Robert Crown Kiln Room HVAC

ADDENDUM No. 2

April 7, 2026

NEW EXHAUST FANS DUCTED DIRECTLY THROUGH WEST WALL

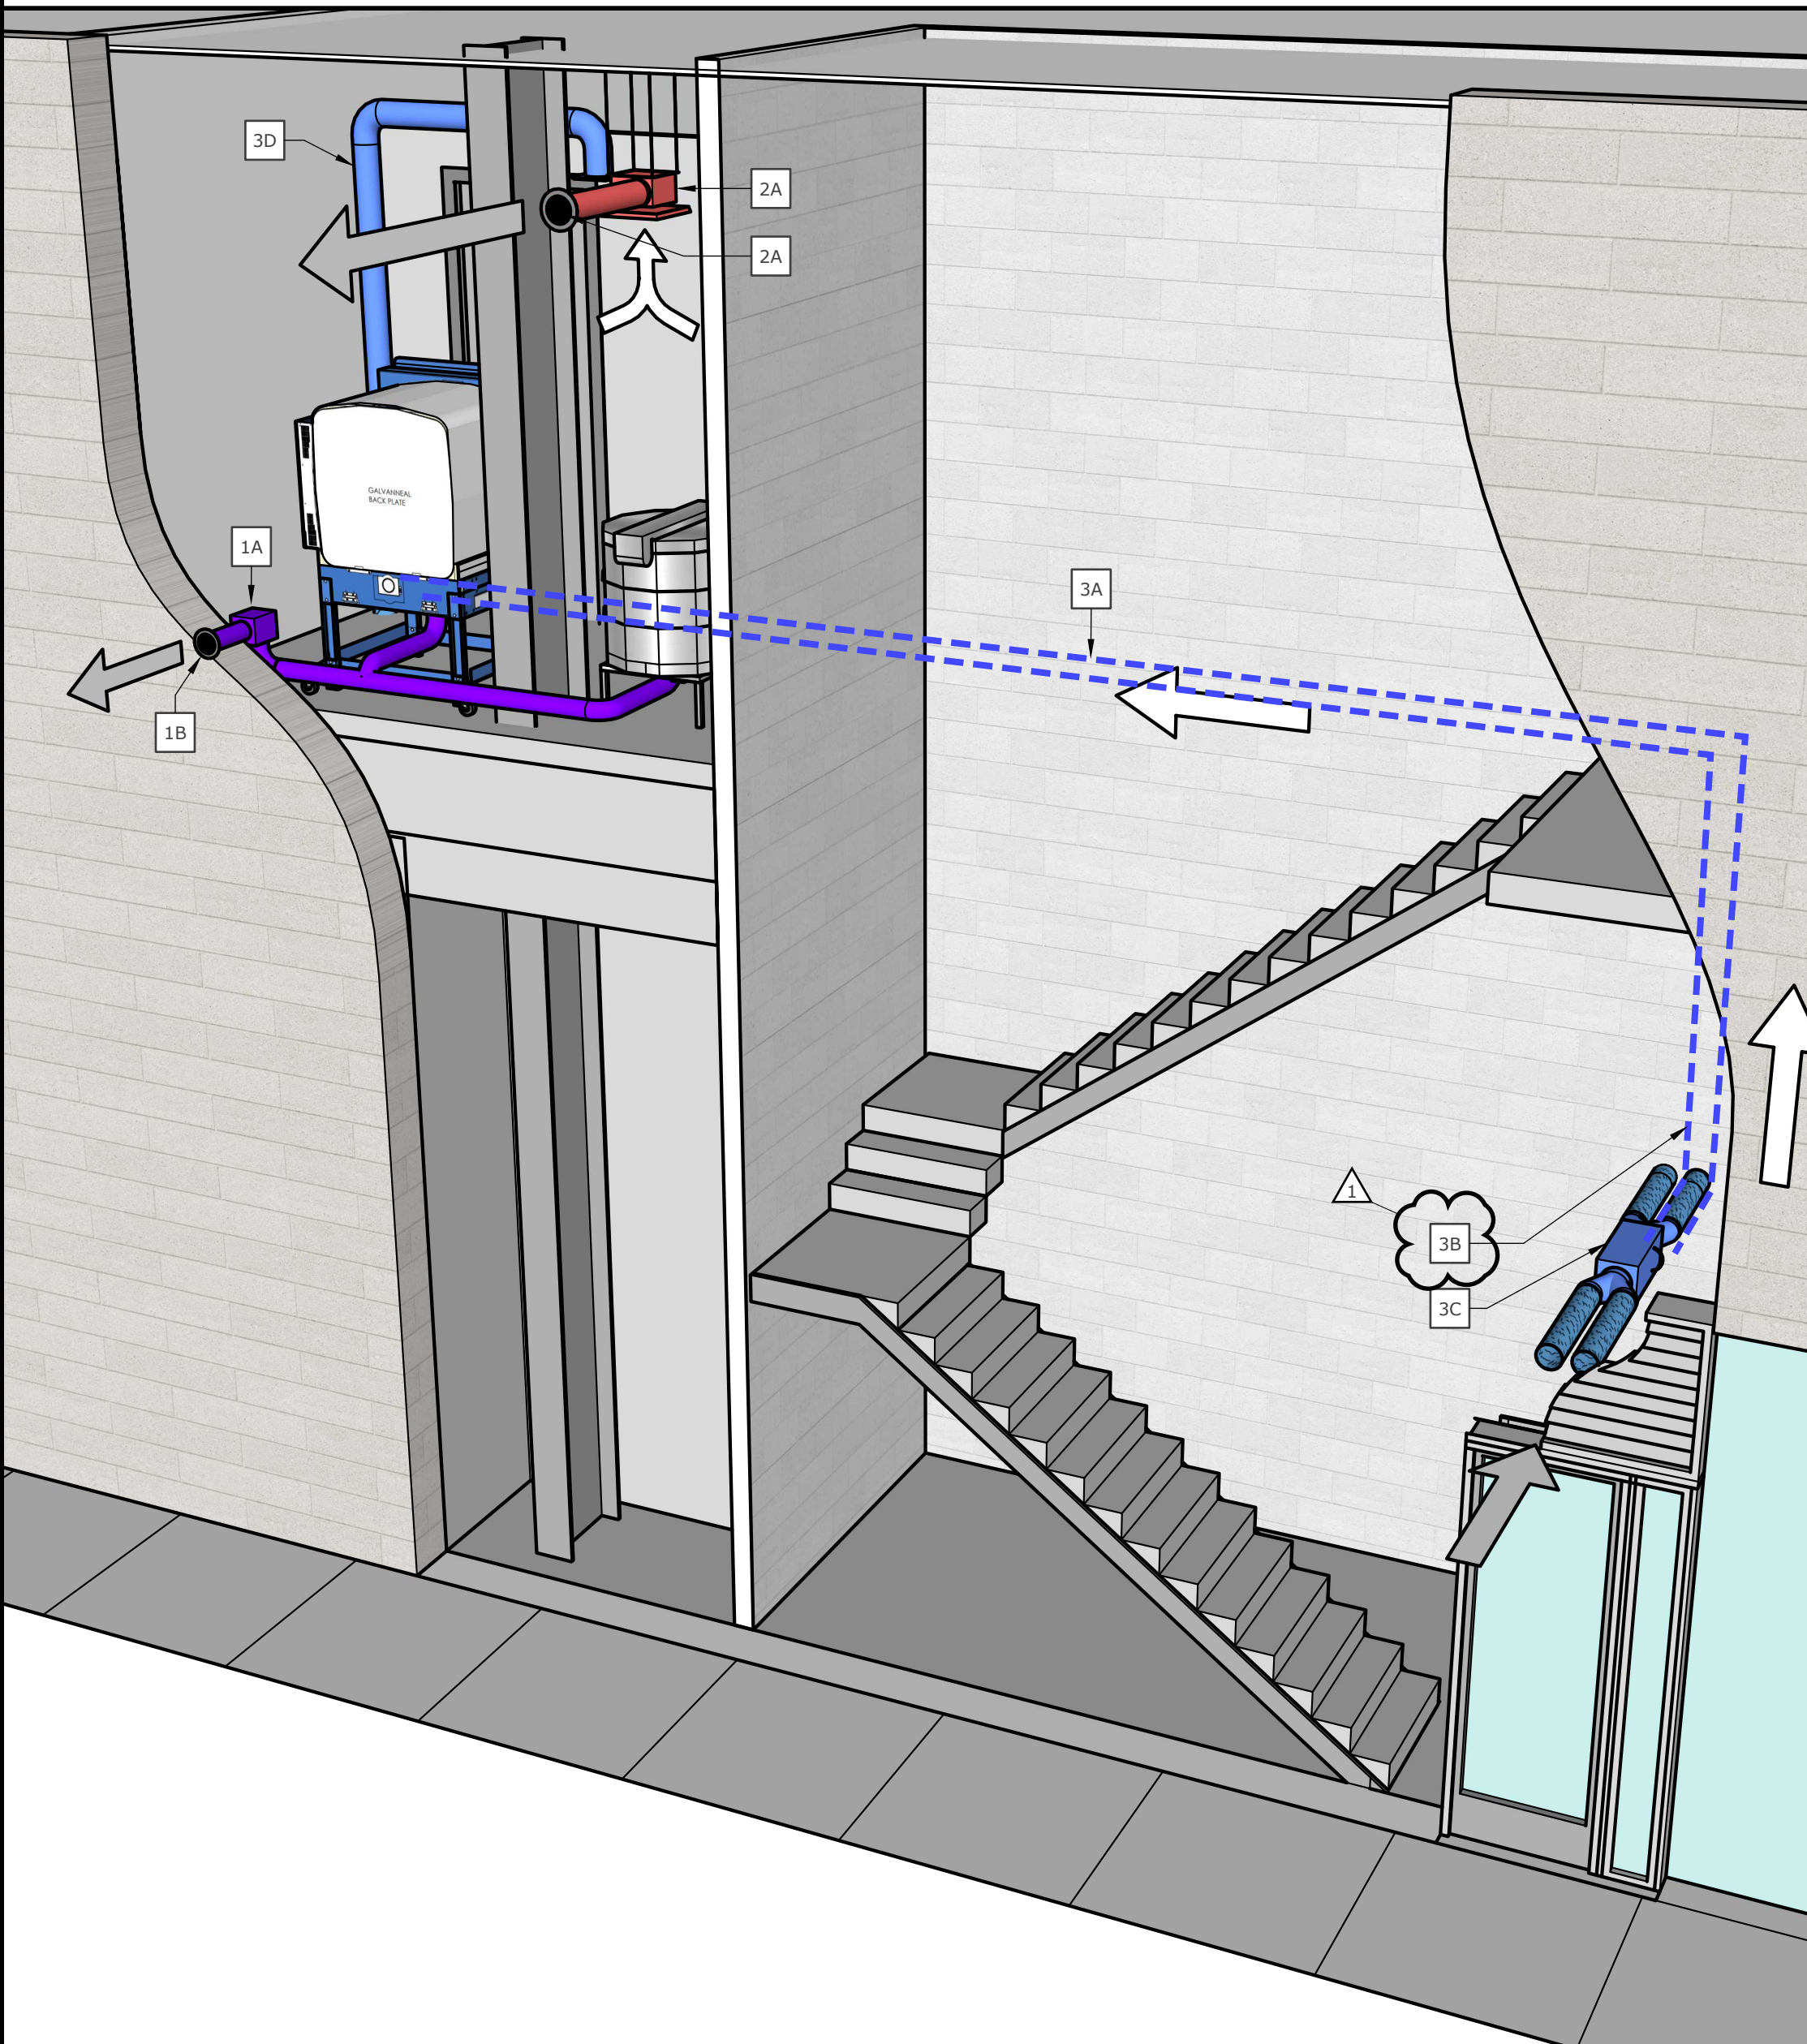
The drawings have been updated to clarify that the existing kiln exhaust ducts should be insulated for their full length.

PHASE 1	
1A	NEW KILN EXHAUST FAN (KEEF-1) DUCTED DIRECTLY THROUGH WEST WALL.
1B	ROUND OUTSIDE AIR LOUVER, 6" ALUMINUM.
2A	NEW GENERAL EXHAUST FAN (GEF-1) SUSPENDED FROM CEILING, DUCTED DIRECTLY THROUGH WEST WALL.
2B	ROUND OUTSIDE AIR LOUVER, 5" ALUMINUM.
3A	EXISTING KILN EXHAUST DUCTS TO REMAIN FOR RE-USE AS MAKEUP AIR.
3B	INSULATE DUCTWORK CONTINUOUSLY FOR THE FULL LENGTH OF THIS RUN.
3C	EXISTING DUCTS COMBINED AND CONNECTED TO NEW FRESH AIR FAN (6" to 4" 2-Way Splitter Duct Connection)
3D	EXISTING DUCTS COMBINED (6" to 4" 2-Way Splitter Duct Connection) INTO SINGLE 6" DUCT EXTENDING TO CEILING, TERMINATING W/ SUPPLY VENT.
